January 20, 2017  
NND-17-0018  
10 CFR 50.90

Virgil C. Summer Nuclear Station (VCSNS) Units 2&3  
Combined License Nos. NPF-93 and NPF-94  
Docket Nos. 52-027 & 52-028

Subject: LAR 17-01: VCSNS Units 2&3 Request for License Amendment:  
Classification of Nonsafety-Related Instrumentation

**Figure 1: Safety Classification of Instrumentation Sensing Line, Manifold, and Instrument**

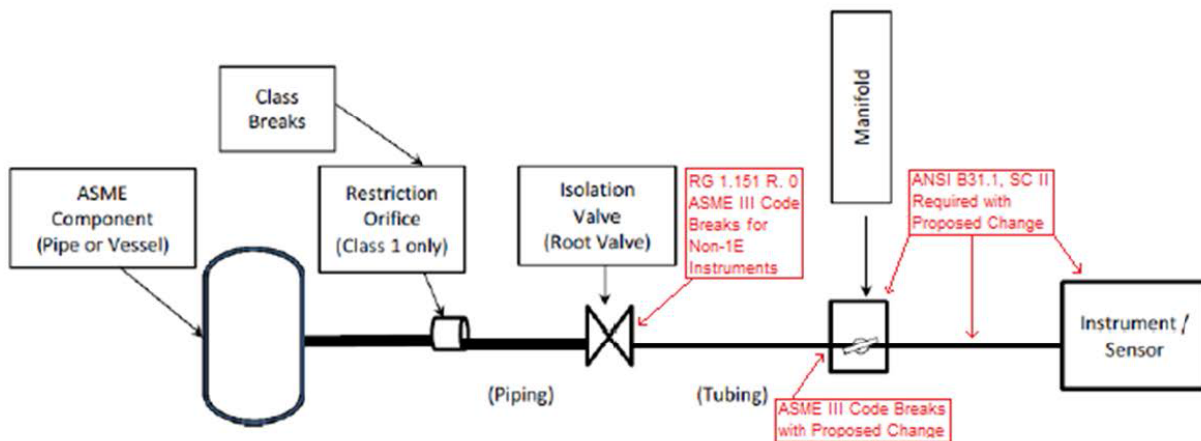
In the absence of specific UFSAR requirements, this amendment request proposes adding a new classification methodology to UFSAR Subsection 3.2.2.8 applicable to the instruments listed in Table 1. Specifically, the proposed activity adds information to UFSAR Subsection 3.2.2.8 to describe that the instrument, manifold, and impulse line of nonsafety-related instruments that monitor safety-related pressure boundaries be classified as equipment Class D, seismic Category II. The instrument sensing line from the system piping to the manifold, including the instrument isolation valve, are proposed to be safety-related, seismic Category I. The equipment class applied to the safety-related portions is proposed to be the same as that of the monitored system, which is the same approach applied to safety-related instruments. The proposed changes are shown in the highlighted portion of Figure 1 below.

**Note:** Section in red border reflects proposed changes, other sections are consistent with current classification methodology.

Plant-Specific Change	Description of Proposed Change
UFSAR Section 3.2.2.8	Revise to state that for nonsafety-related instruments interfacing with safety-related pressure boundaries, the instrument sensing lines and isolation valves have safety-related pressure boundary function, and the instrument manifold, sensor and impulse line are nonsafety-related and seismic Category II.
